RFI

RFI #: 217
Date: 1/3/2013
Job: EB-02 Keller Springs Lofts
Phone: 877-777-5115

Subject: Details needed for concrete pole base

SHEET
1C OF 9

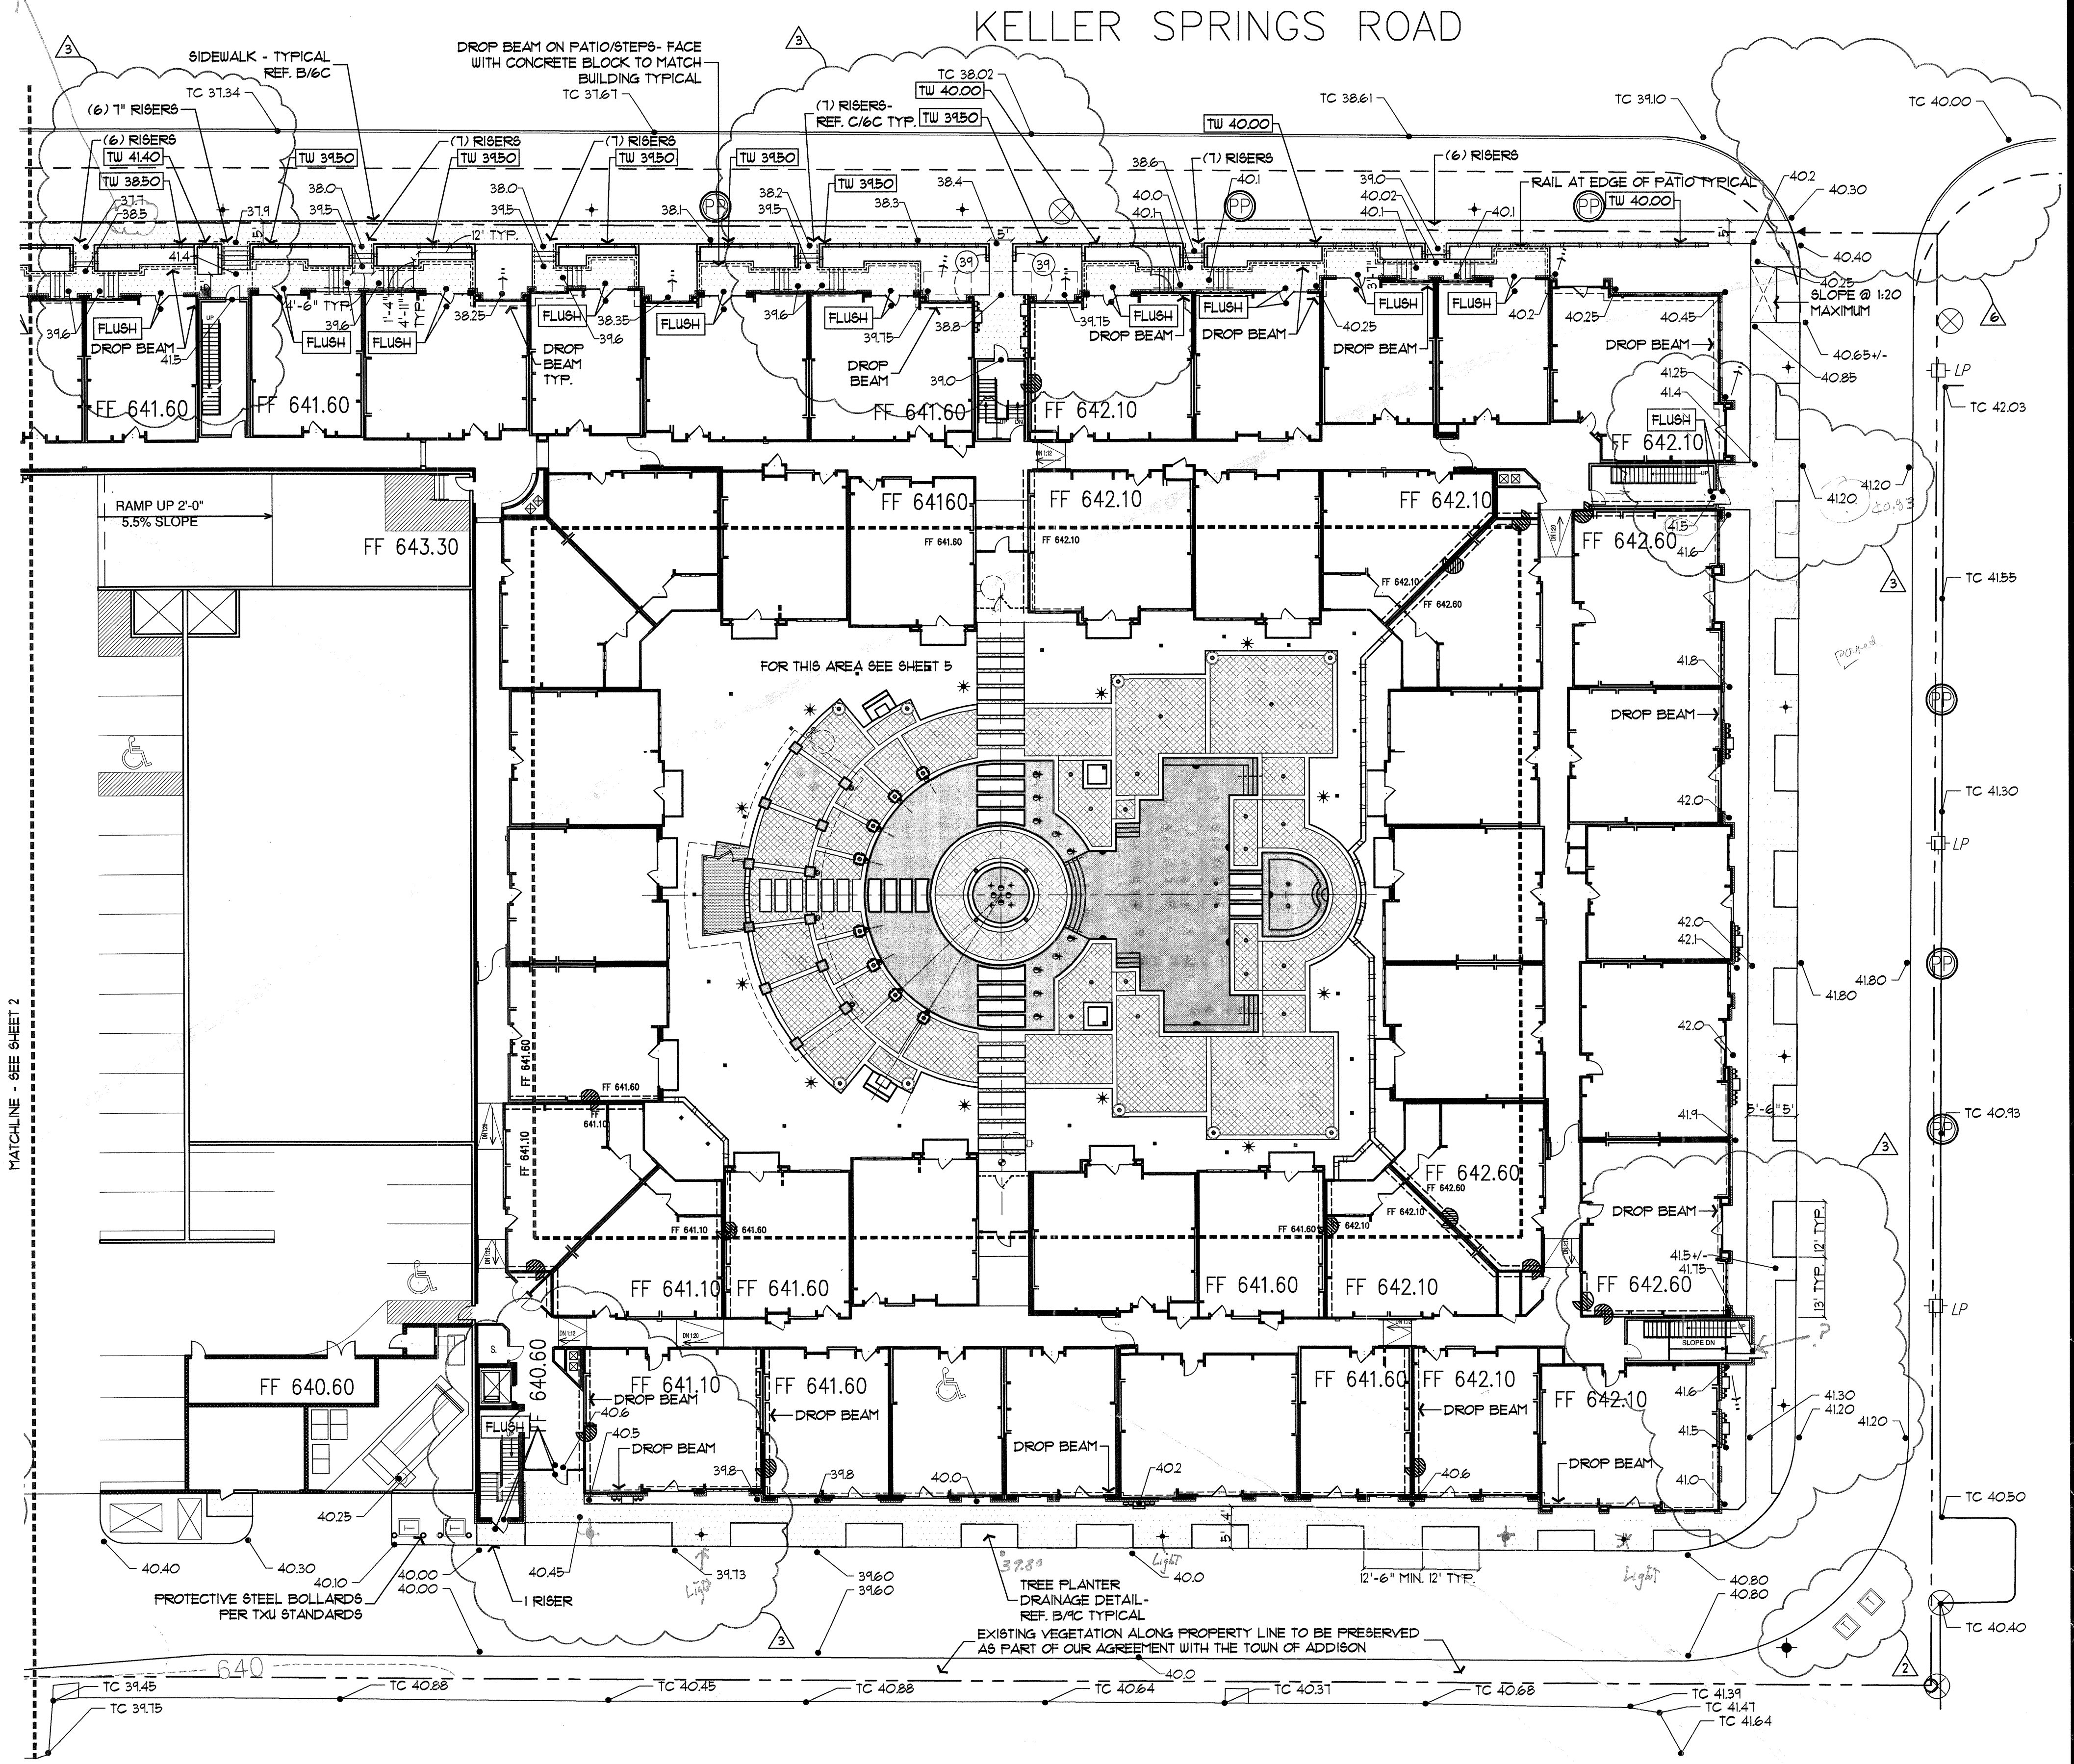
Request: **Date Required:** 1/9/2013
There is no detail for the site pole light base supports. Attached are the specs. for the poles along with the connection plate template. Please provide the concrete pole base specs. where shown on hand drawn sketch.

Response:
See attached drawing, SK-11, for the requested light pole foundation

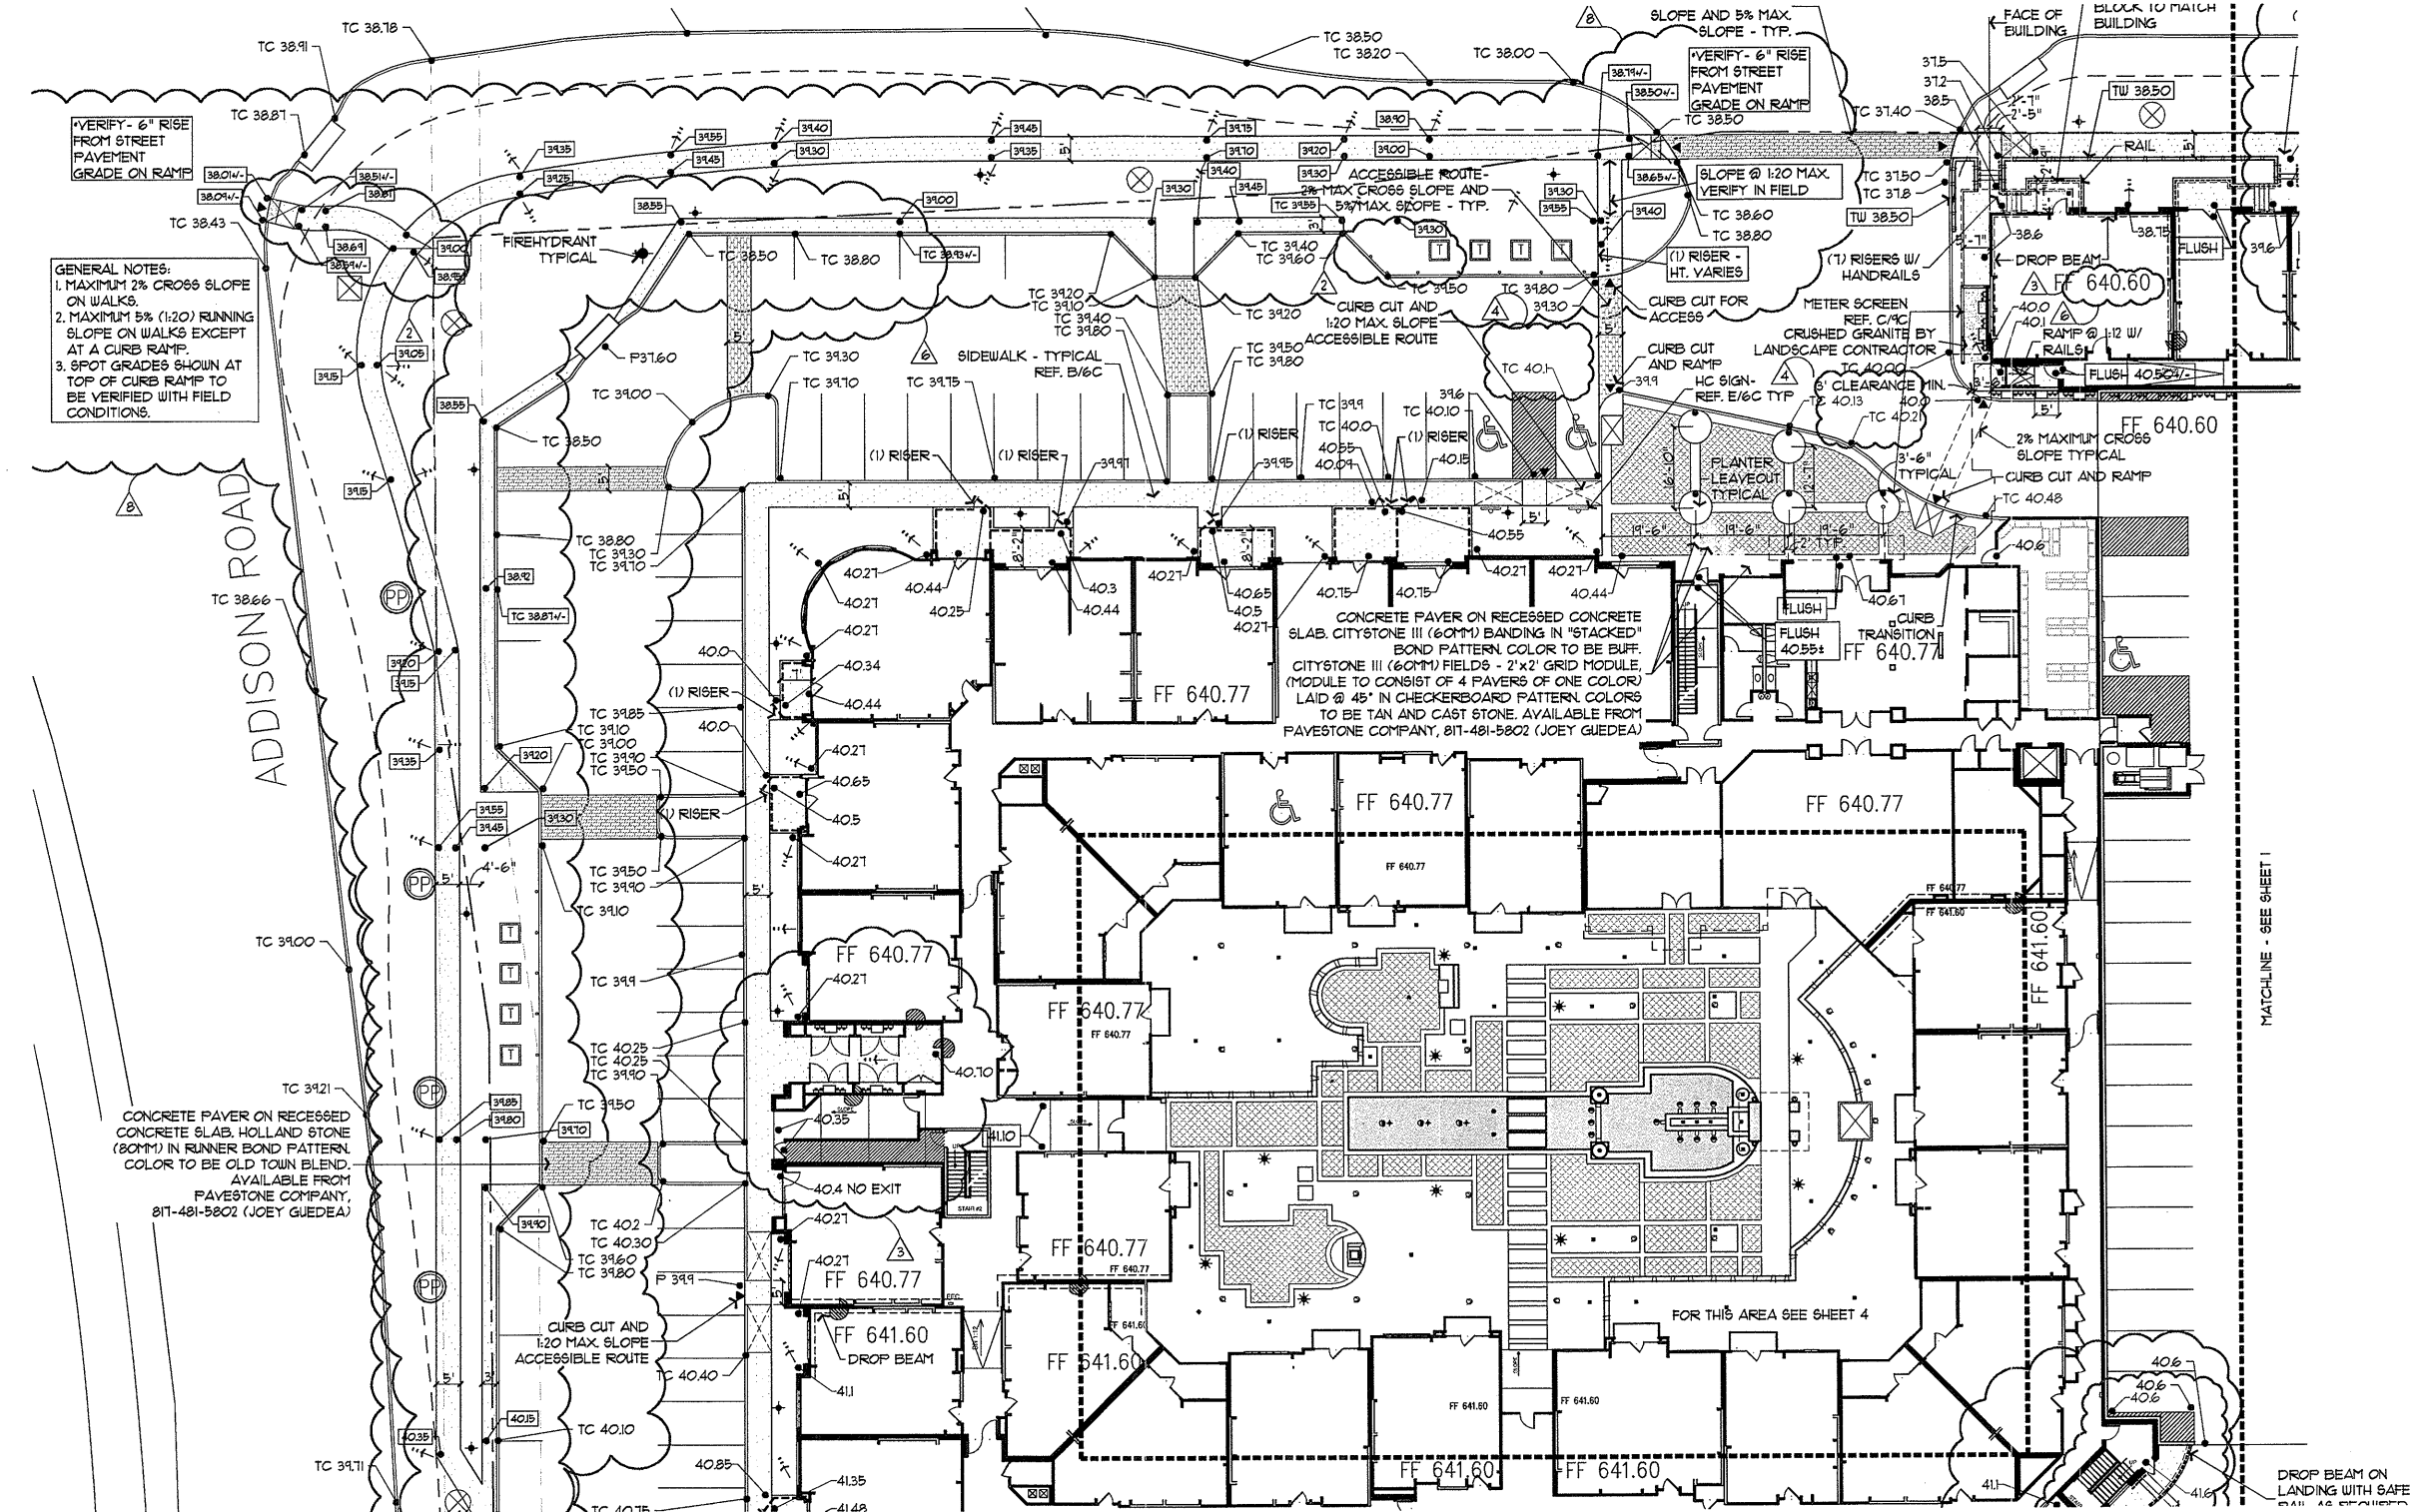
Request: Date Required: 4/20/2012
 Architectural and Structural plans show FF at 640.6'. Landscape shows 641.6. Please confirm the correct elevation is 640.6'.
 Architectural shows a spot elevation outside the building at 640.5'. Landscape shows a spot elevation of 640.1' at the bottom of the ramp and 640' in the street just outside. Please confirm the correct spot elevations.

Response:
 * THE CORRECT FINISH FLOOR ELEVATION IS 640.60. WE WILL UPDATE OUR DRAWINGS. SPOT ELEVATION ADJACENT TO EXTERIOR OF UNIT AREA CORRECT AS SHOWN.
 * THE SPOT ELEVATION AT THE BOTTOM OF RAMP SHOULD BE 640.0, AND THE LANDING AREA AT THE BOTTOM OF RAMP CAN NOT BE 640.0 CROSS SECTION.
